UNITED STATES PATENT AND TRADEMARK OFFICE

Office Action Summary	Application No. 10/691,213	Applicant(s) RESING ET AL.	
	Examiner Árpád Fábíán Kovács	Art Unit 3671

DETAILED ACTION

Stalk roll's
front of the
roll

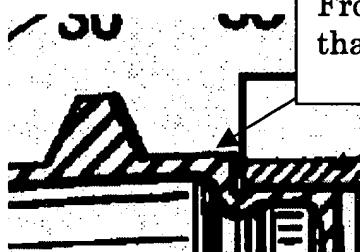
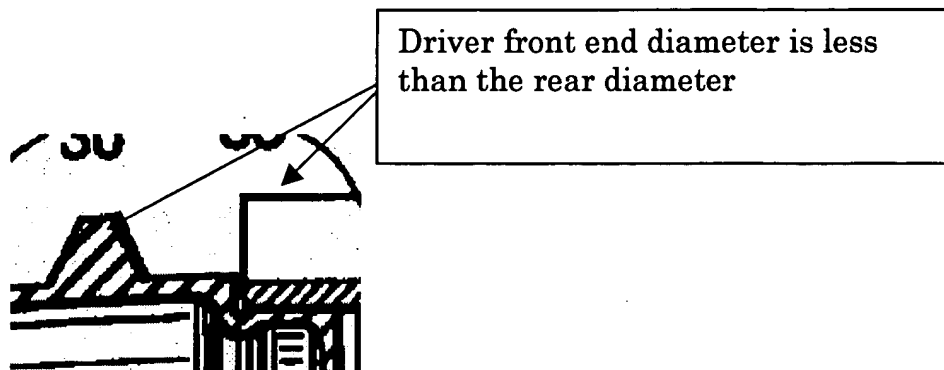
Rear end of
the roll

Front body's diameter is greater
than the rear body

Applicant argued that the stalk roll “have the same diameter in the front as the back.” It is incorrect. It is for that reason the examiner included screenshots in the Office action to show this design aspect.
